ORIGINATION FORM

Proposed Revisions to a Standard Plans Index

Index Number: 455-400

Index Title: Precast Concrete Sheet Pile Wall
(Conventional)**Summary of the changes:**

SECTION THRU BULKHEAD
 (Showing Plastic Filter Fabric)

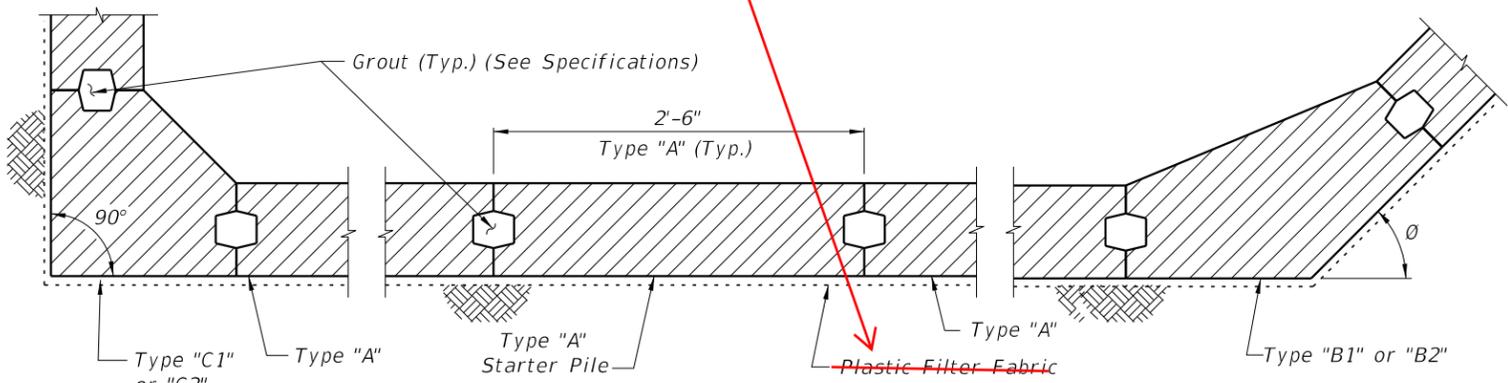
Sheet 1: Changed the "PLASTIC FILTER FRABRIC" Note in the SHEET PILE DESIGN CRITERIA AND NOTES to "GEOTEXTILE: Provide and install Type D-2 or D-3 geotextile in accordance with Specifications 514. Extend the geotextile to the bottom of the "X" dimension."; Changed all references of "Filter Fabric" or "Plastic Filter Fabric" to "Geotextile".

PLASTIC FILTER FABRIC:
~~The plastic filter fabric shall extend to the bottom of the "X" dimension.~~

Plastic Filter Fabric
 (Continuous)

CHANGED: Geotextile

CHANGED:
 Provide and install Type D-2 or D-3 geotextile in accordance with Specifications 514. Extend the geotextile to the bottom of the "X" dimension.
